**WASHINGTON METROPOLITAN AREA TRANSIT AUTHORITY
SUPPLY AND SERVICE CONTRACT CQ116028**

**WASHINGTON METROPOLITAN AREA TRANSIT AUTHORITY
600 Fifth Street, NW, Washington, DC 20001-2651
AMENDMENT OF SOLICITATION / MODIFICATION OF CONTRACT**

Appendix A
Questions and Answers
CQI16028

Figure 10-12. Compressor Assembly (680D5136)

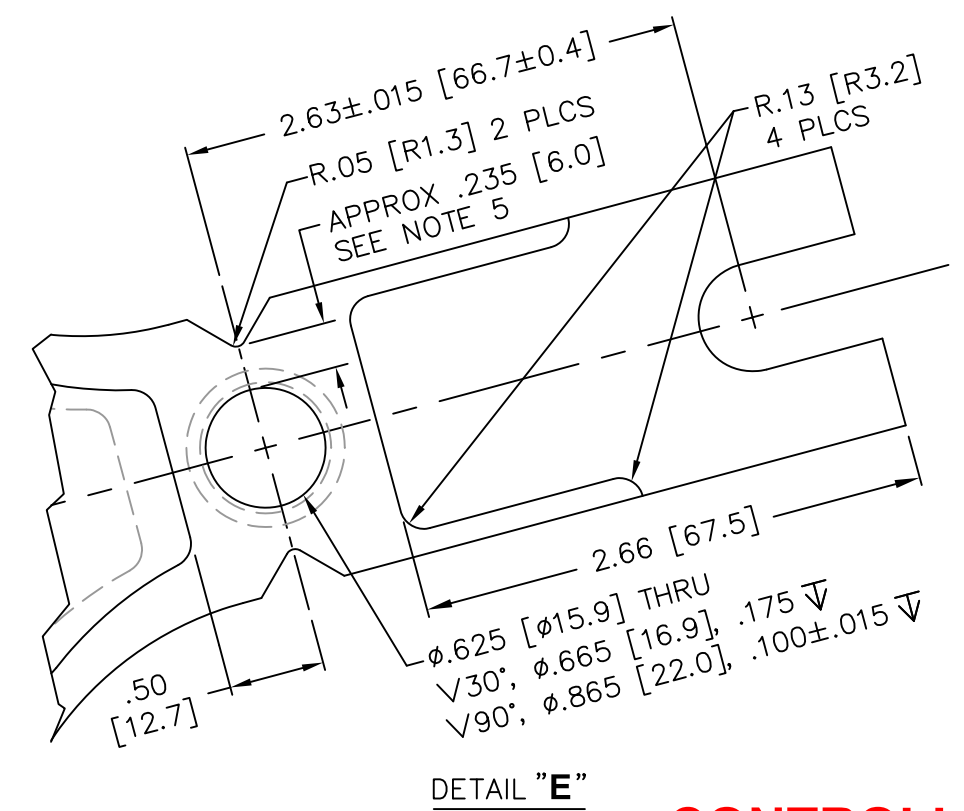
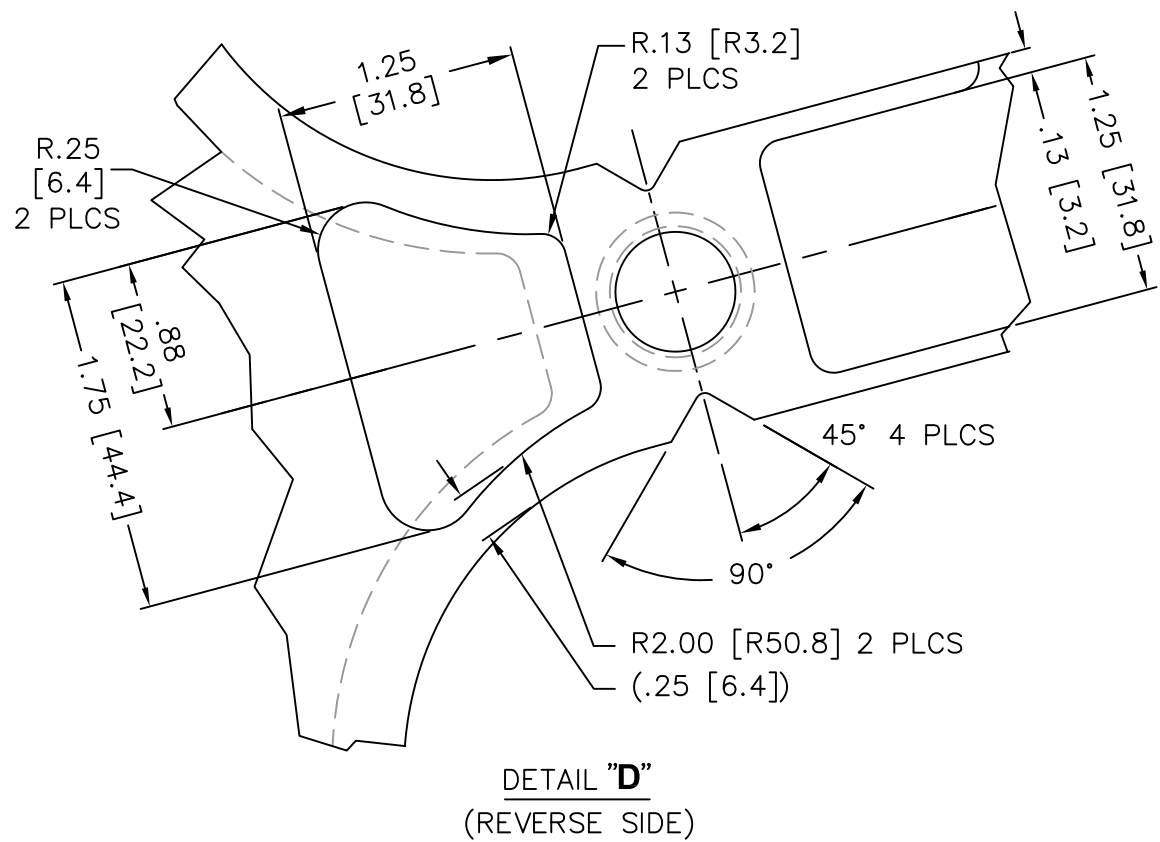
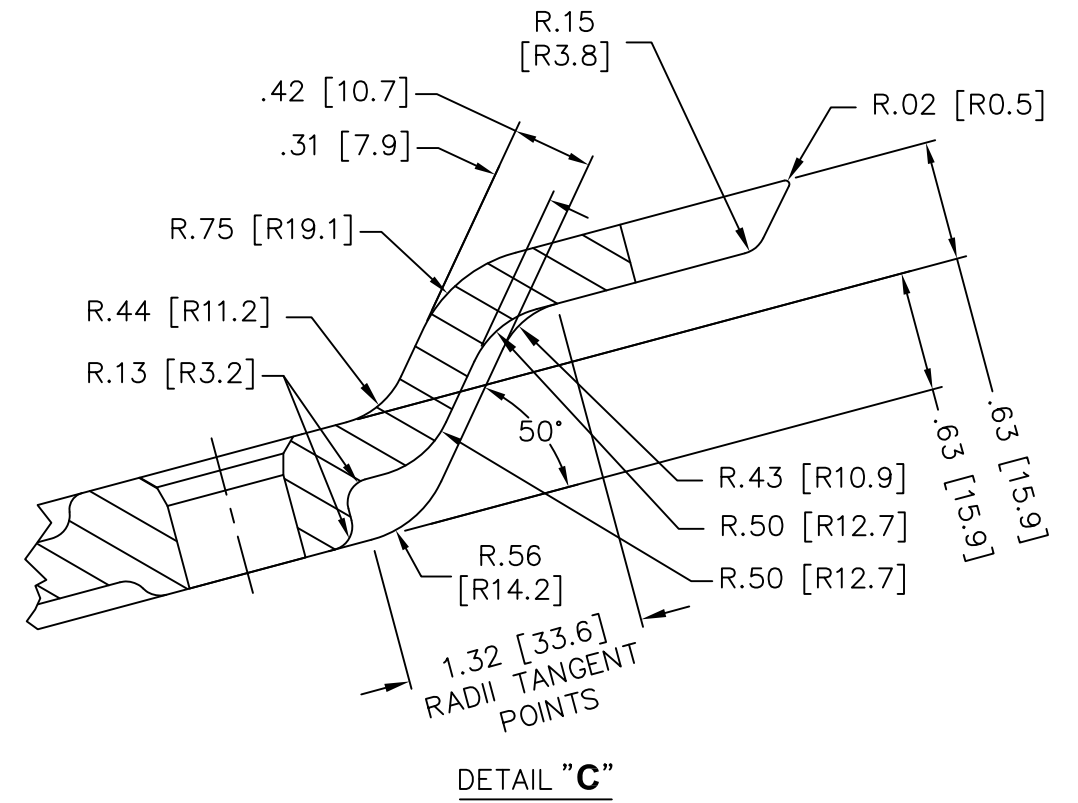
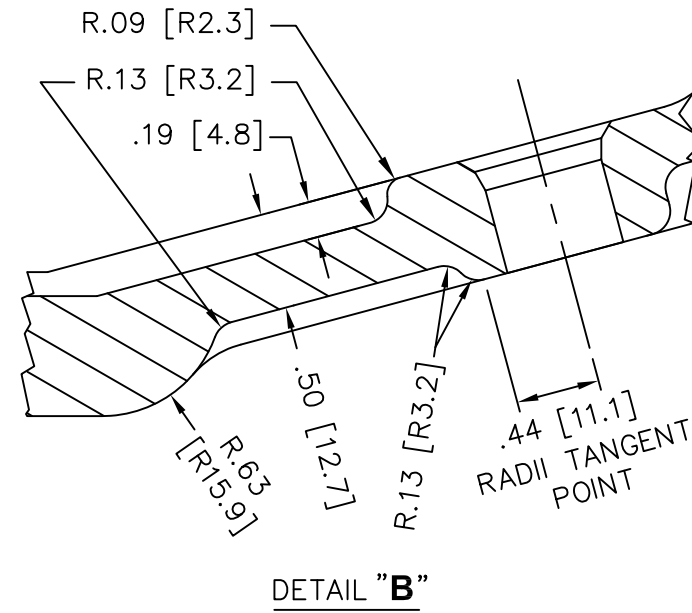
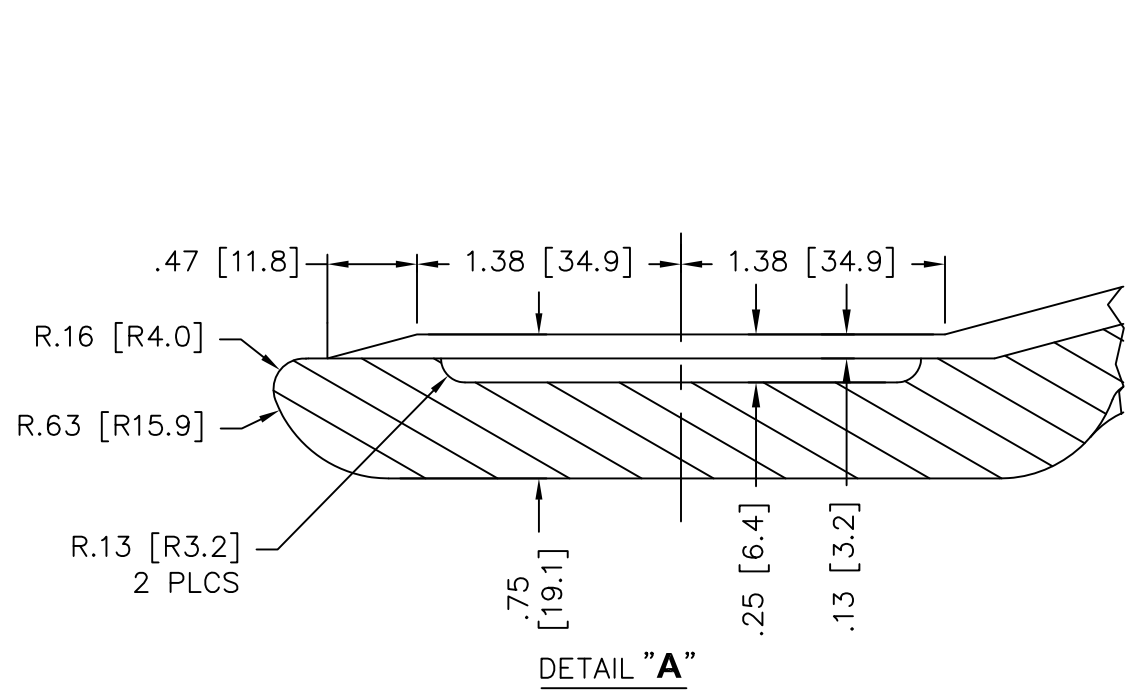
Question 2: Can you please provide a drawing of A18347045?

Answer: There is no drawing on file for item A18347045. There is an illustrated parts catalog. Please see number 2 on attachment A18347045.

REVISION LOG				1:2 or AS NOTED	A		Dwg. No. CL000413 <small>Sheet 1 of 1</small>

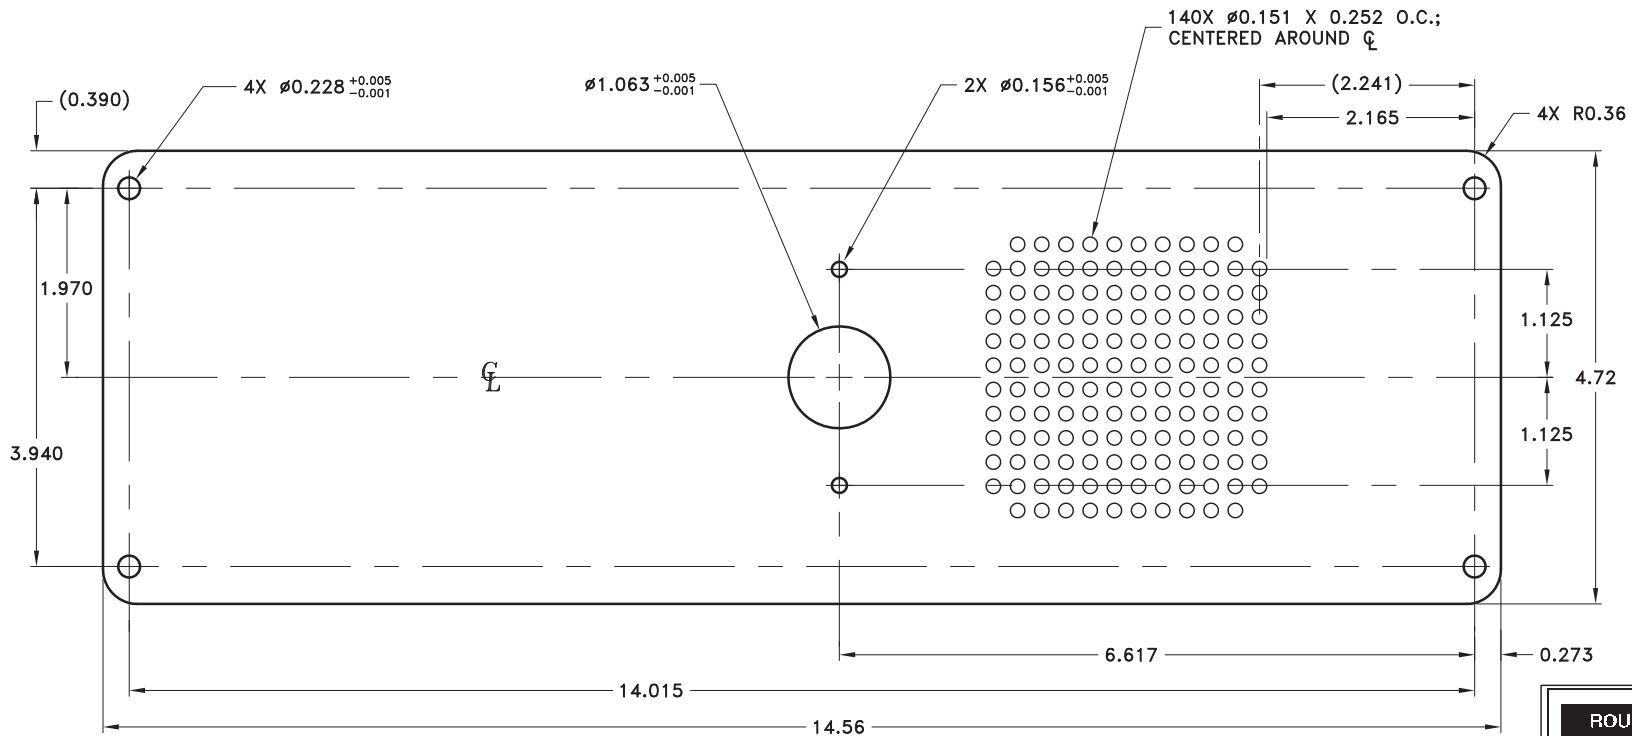
Question 3: L76903031 – L76903047 - R18115385 (dwg CL000413) maybe I could get a copy of this drawing.

Answer: Drawing for L76903031 and L76903047 are not available. R18115385 attached.
